Spreeukloof Wind Energy Facility, Eastern Cape Province

Final Motivation for amendment of Environmental
Authorisation

DEA Ref.: 12/12/20/1778/5

October 2021

Figure 2.3: Wind farm layout showing the proposed amendment (2021) layout with reduced turbine number and revised turbine specifications (A3 Map included in Appendix I)

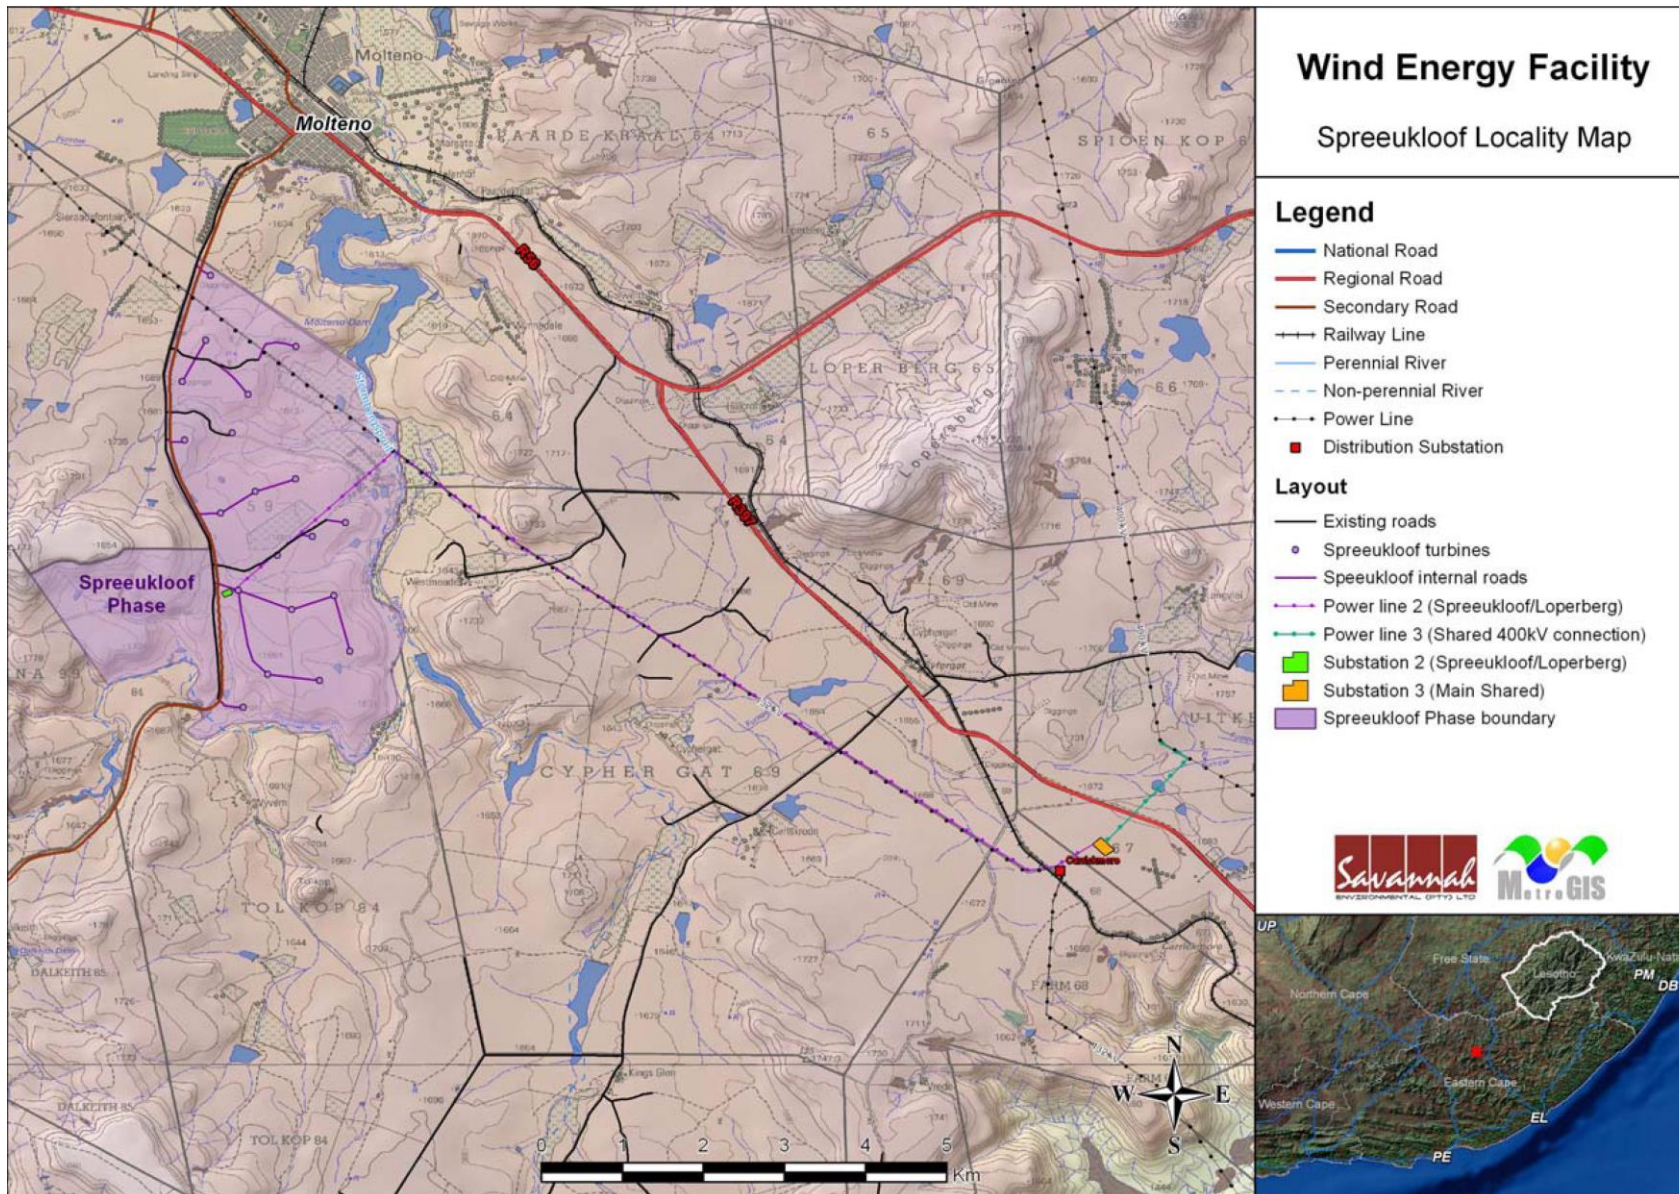
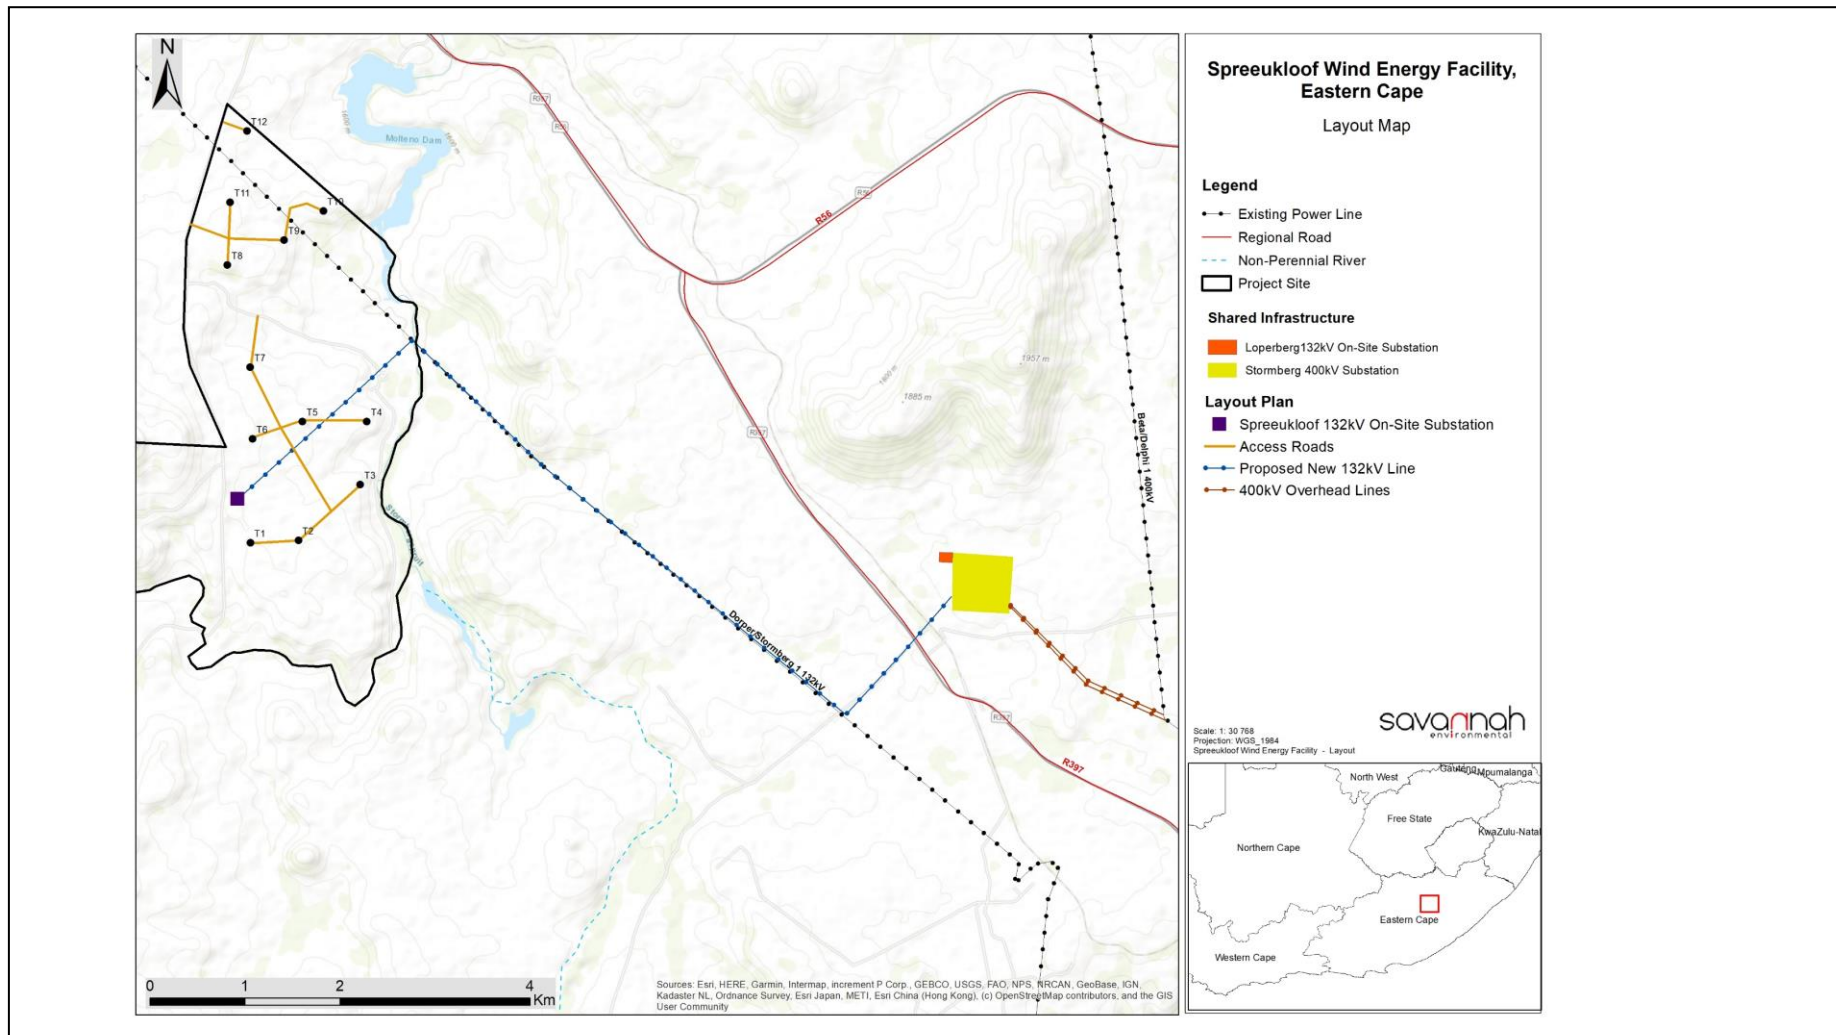
The number of wind turbines are proposed to be decreased from the currently authorised 21 turbines, to 'up to 12' turbines. It is therefore requested that the project description in the EIA be amended to include the revised number of turbines.

The layout of the facility as submitted in the final EIA Report (2012) is indicated below in **Figure 2.1** overleaf. Furthermore, the combined sensitivity map as utilised in the final EIA Report (2012) is shown in **Figure 2.2** and a proposed layout assessed as part of this amendment is indicated in **Figure 2.3**.

A layout indicating the 12 turbine positions is provided in **Figure 2.3**. It must be noted that this amendment request is not for final approval of the facility layout as per the facility EA conditions. This will be undertaken following the detailed design for the project in accordance with the requirements of Condition 28 of the EA (dated 2 November 2012).

Figure 3.1: Wind farm map showing the previous routing of the power line (2012) solution between Loperberg, Malabar and Spreeukloof WEF and a new proposed powerline routing (2021) (A3 Map included in Appendix I).

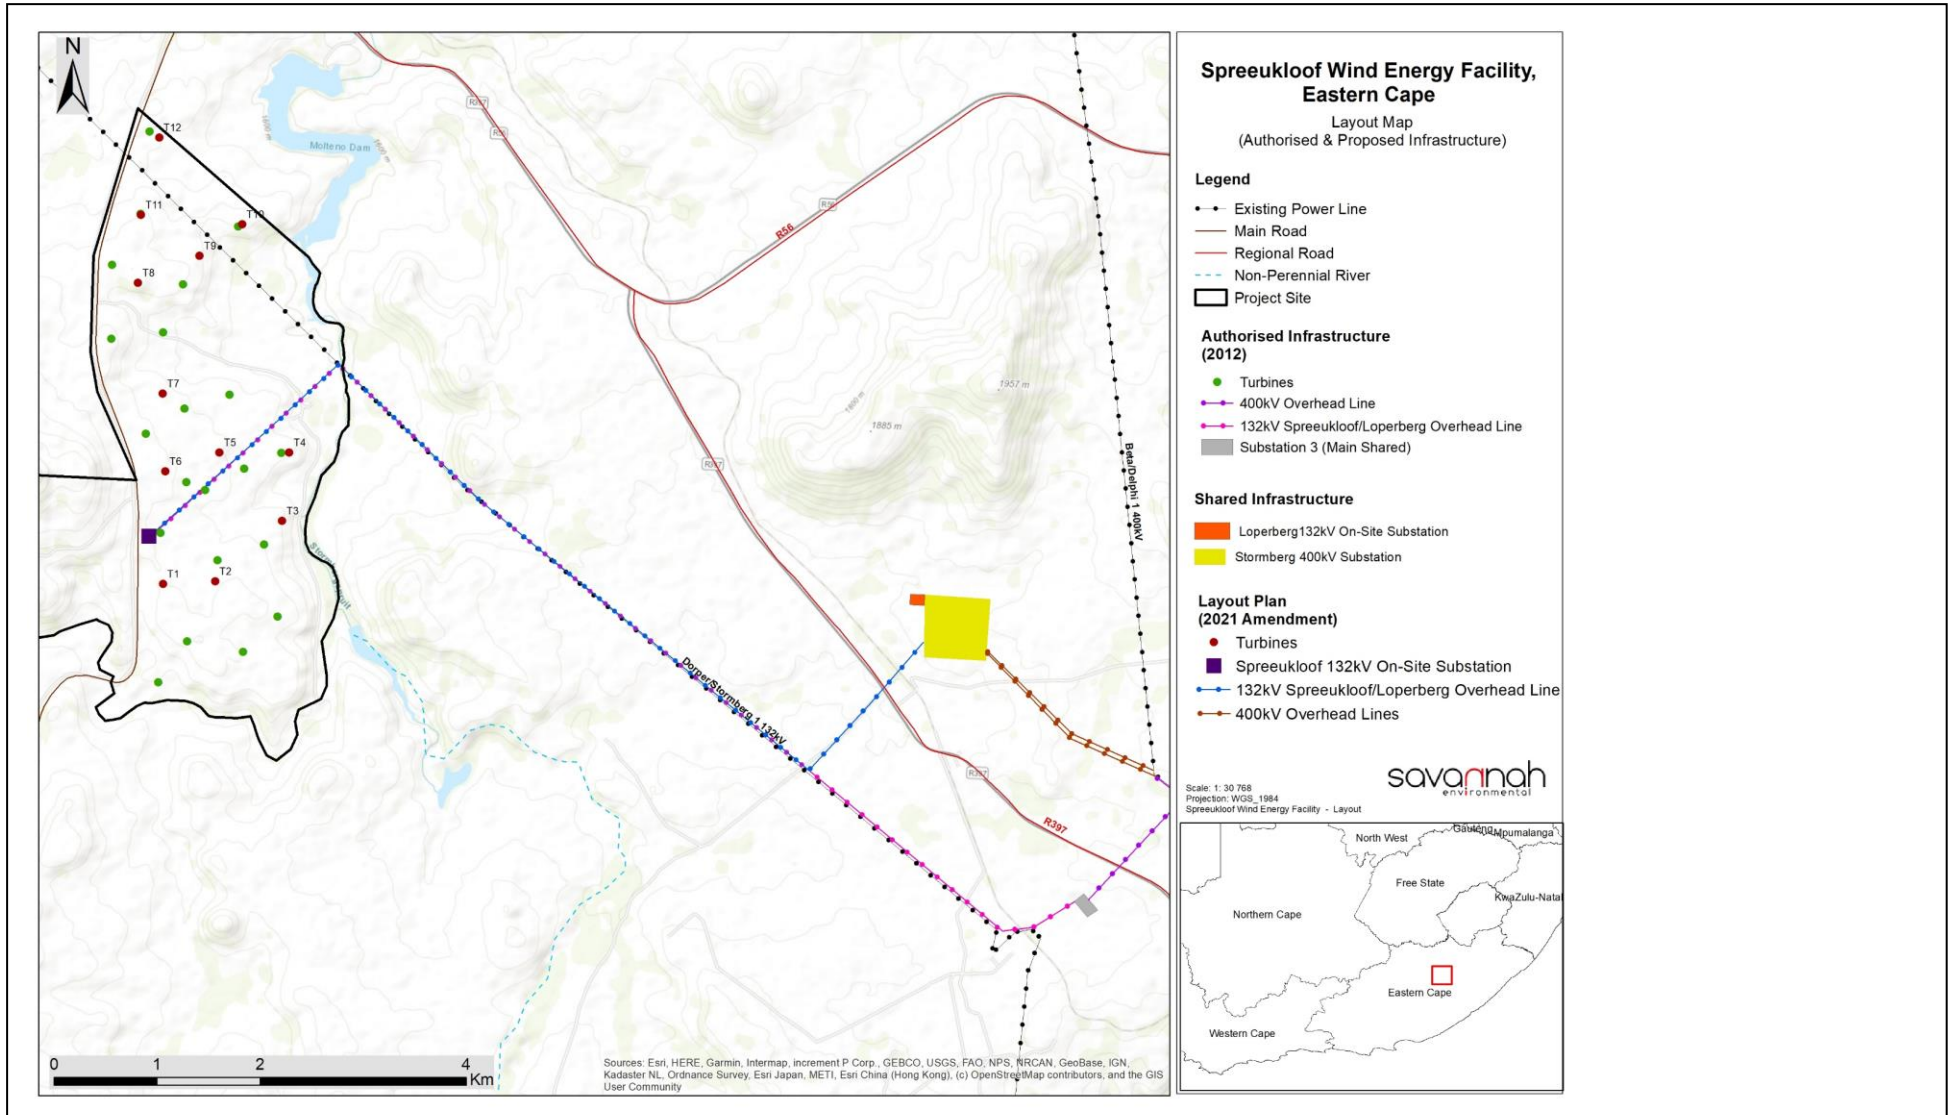
In addition, given the terminating substation location has changed, the grid connection route thereto has is required to change accordingly. The revised grid connection route is therefore requested for specific inclusion into the EA to ensure that the amended grid connection route reflects accurately in the EA.

The resulting change in grid connection route and substation location will result in the reduction of the length of the powerline by ~1.5km, and will reduce the length of powerline required to cross delineated freshwater features. Please refer to Chapter 5 for a detailing of the impacts related to the proposed amendment. The revised grid connection route will now be located along the proposed access and internal road of the facility, allowing for easy access for maintenance and the reduction in maintenance roads required for the power line.

**Figure 5.1: Indicative diagram of the original and proposed rotor swept areas. Not to scale.
Change in overall risk window presented by facility**

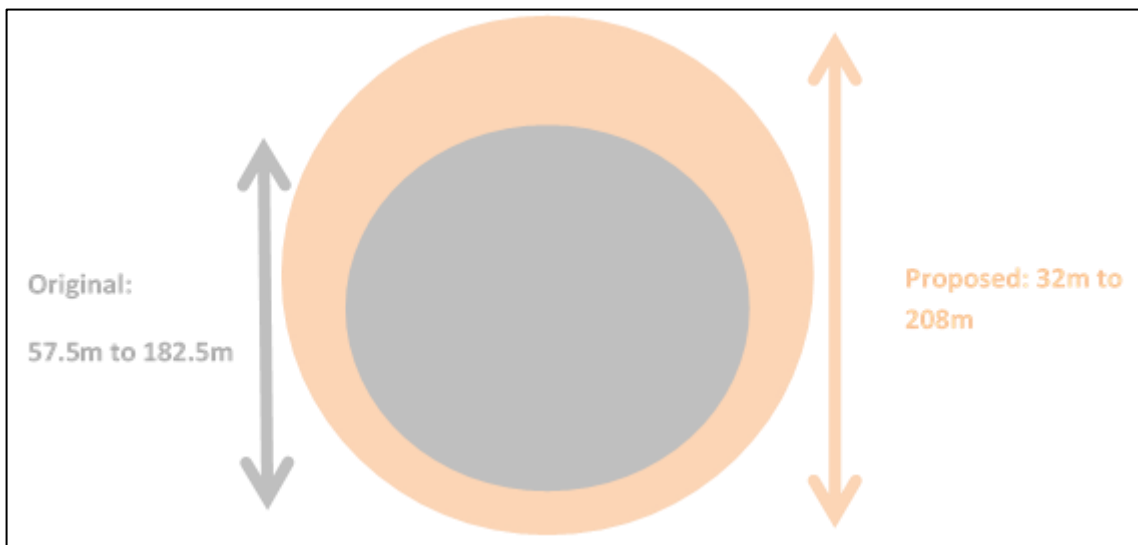
For the purposes of this analysis, the avifaunal specialist assumed the largest turbine model within the range applied for, as a worst-case scenario. The original authorised model would have had a rotor swept area from 57.5m to 182.5m above ground. The new proposed turbine would have a rotor swept area of 32m to 208m above ground if the maximum hub height is used. **Figure 5.1** below shows the two rotor swept area scenarios. The lower tip of the proposed new rotor drops by 15.5m. This is a slight disadvantage for avifauna as much of the typical bird flight is in the first 20-40m above the ground. Dropping the blade tip therefore slightly increases collision risk. Whichever hub height is used, the lower blade tip is not lowered below 30m above ground.

The turbine model authorised originally had a maximum 125m rotor diameter and therefore presented a collision risk window of 12 271.85m² per turbine. The proposed change to a maximum 176m rotor diameter will increase the collision risk window presented by each turbine to 24 328.49m². This almost doubles the per-turbine collision risk window. The number of proposed turbines has however reduced from 21 to 12. The overall wind farm collision risk window would therefore increase from 257 708.85m² (21 x 12 271.85m²) to 291 941.88 (12 x 24 328.49m²). This represents an overall increase of 13.2%. This is also added to by the lower blade lowering.

Figure 5.2: Bat sensitivity map for the amended scenario.

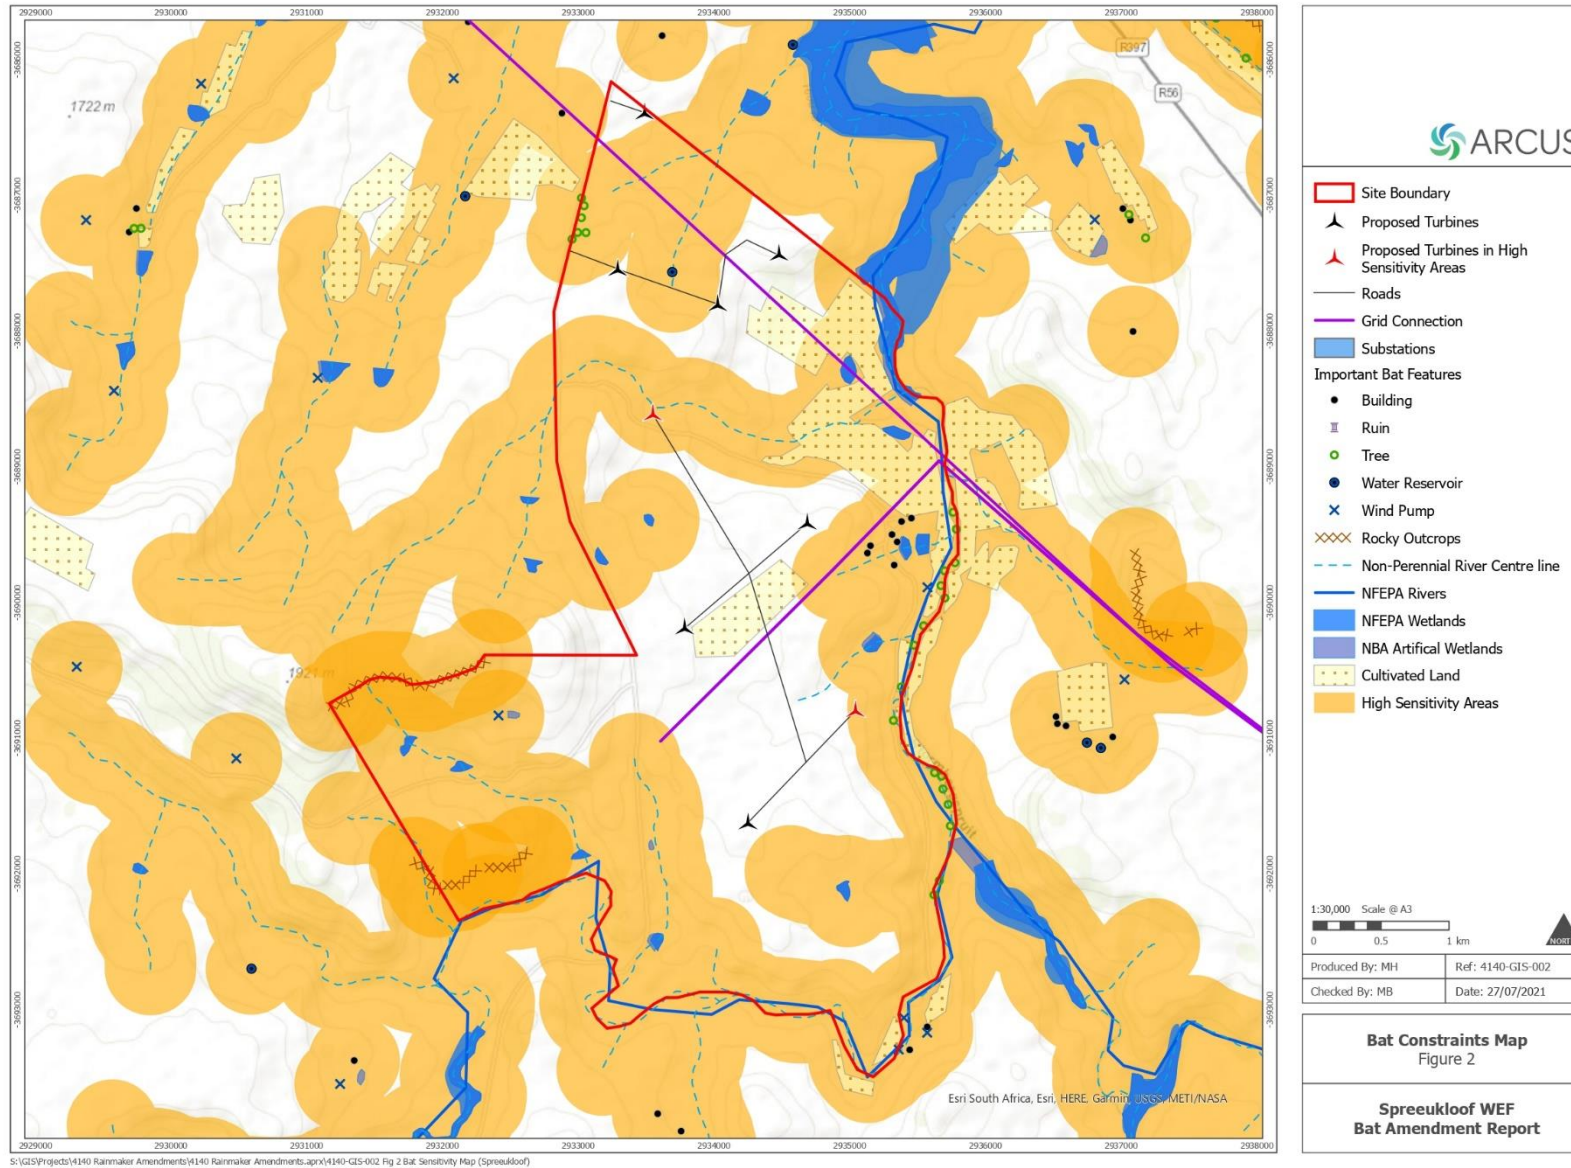
- » All currently proposed mitigation measures proposed in the Spreeukloof WEF EMPr / EA must be adhered to. This includes adhering to the updated sensitivity map (**Figure 5.2**) which will require repositioning 2 turbines that intrude into high sensitivity buffers. These buffers are regarded as high sensitivity areas for turbine components only, and other infrastructure (roads, cables etc) are permissible. These areas include 200m around all cliff lines potential roosts and all other important bat features. Should important features, including wind pumps and water reservoirs be removed or covered, these buffers would not apply and can be removed.
